Subject: Submittal of APP-GW-GLE-002 Revision 7 – “Impacts to the AP1000TM to Address Generic Safety Issue (GSI) - 191”

APP-GW-GLE-002 Revision 7

Title: Impacts to the AP1000 DCD to Address Generic Safety Issue (GSI)-191

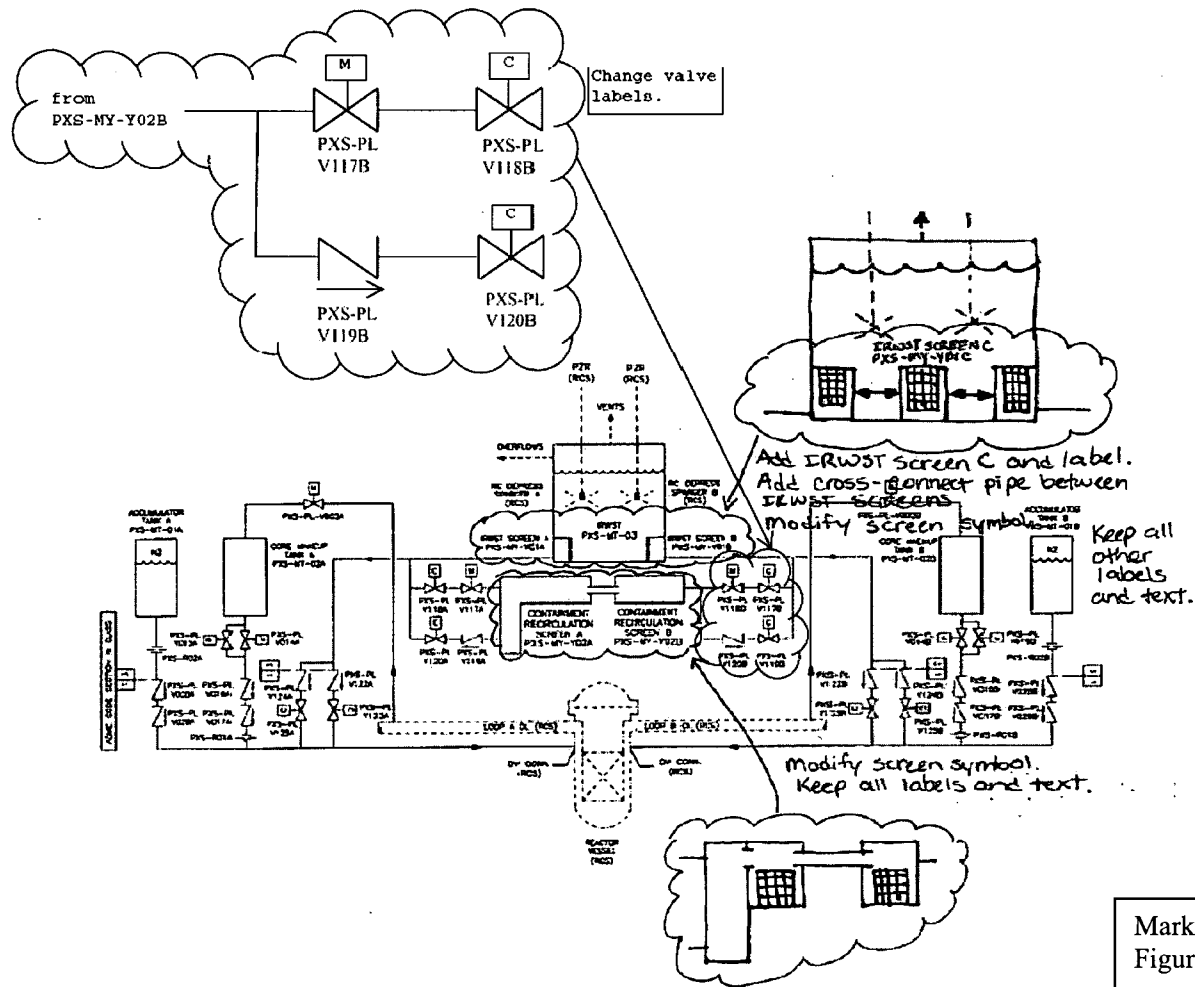
Justification for changes to Tier 1, Figure 2.2.3-1: Correct valve labels on Train B valves downstream of Containment Recirculation Sump Screen B. Valves were incorrectly labeled when Figure was rearranged in APP-GW-GLE-002, Revision 1. ***6***

Justification for changes to Tier 1, Figure 2.2.3-1: Add new IRWST Screen C and cross-connect piping between IRWST screens based upon changes in APP-GW-GEE-1145. ***5***

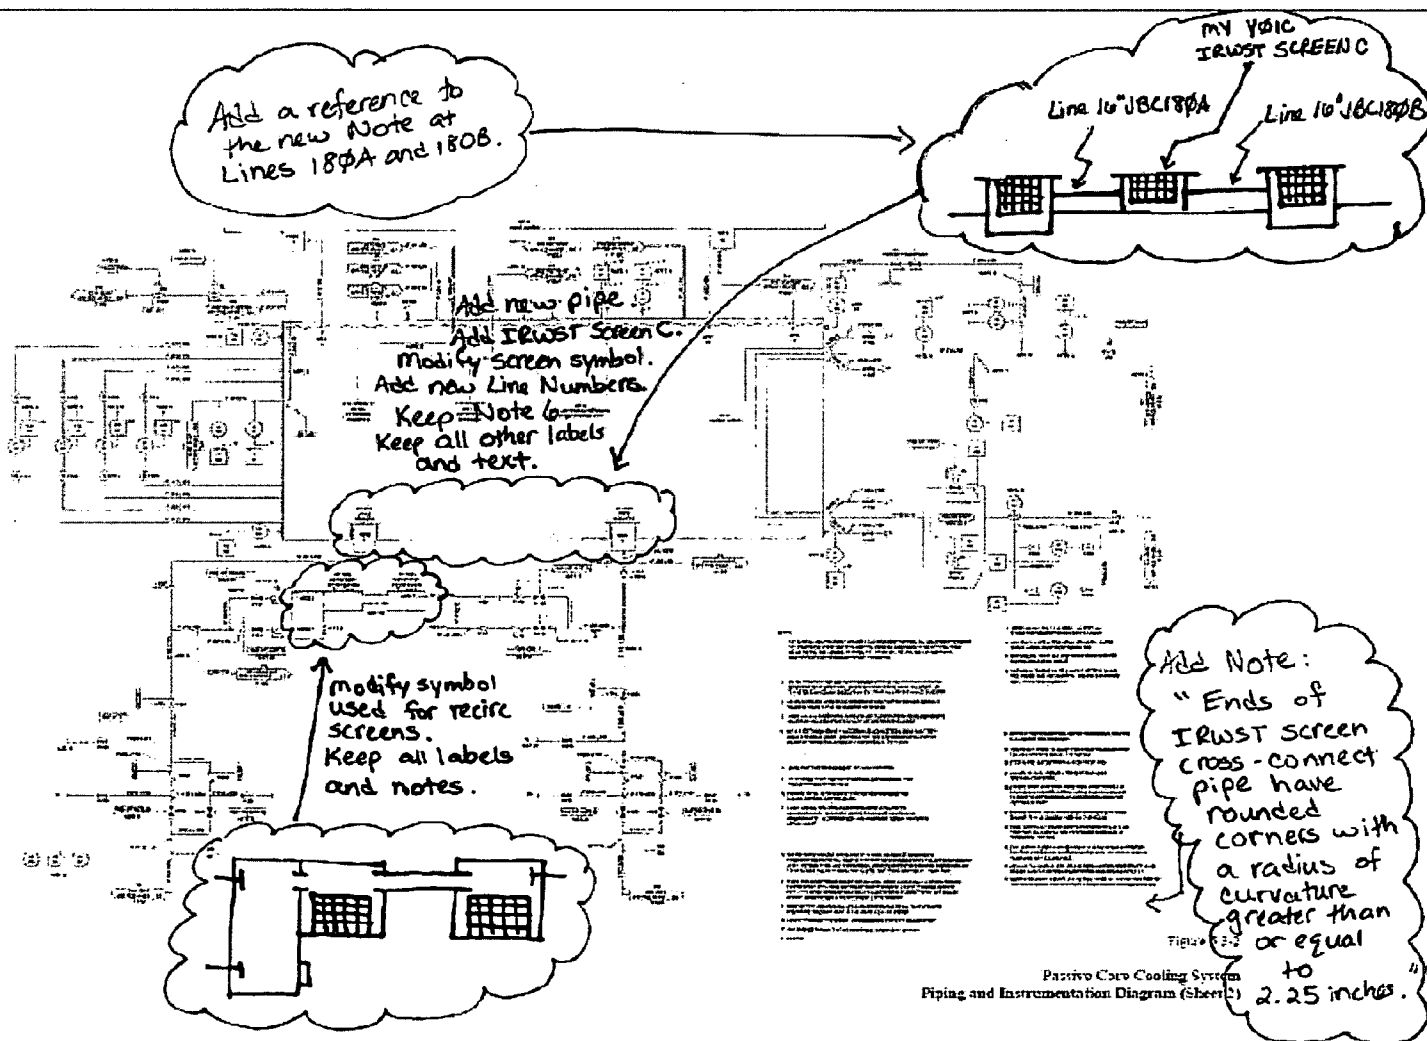
Justification for changes to Figure 6.3-2: Add new IRWST Screen C and cross-connect piping between IRWST screens based upon changes in APP-GW-GEE-1145.

Justification for changes to DCD Tier 2 : Figure 6.3-2, note 13, should be amended to identify that the gutter drain line termination point is well away from the IRWST screens and close to the tank floor to facilitate settling of coating debris before it is transported to the IRWST screens.

Figure 6.3-6

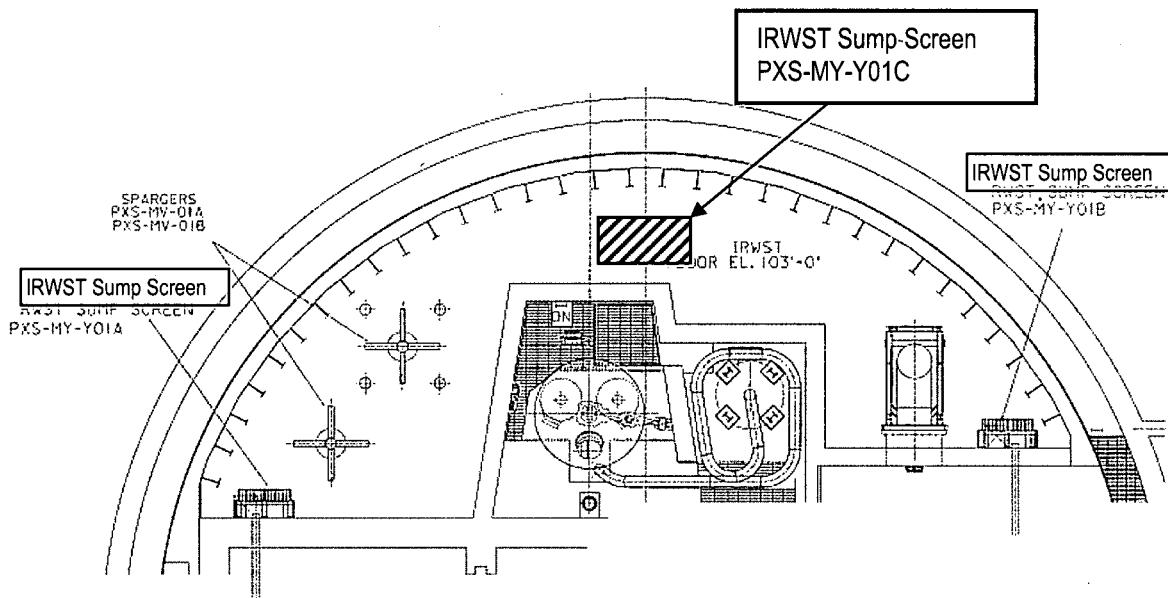
Justification for changes to DCD Tier 2 : Figure 6.3-6: Add IRWST Screen C to reflect changes in APP-GW-GEE-1145.
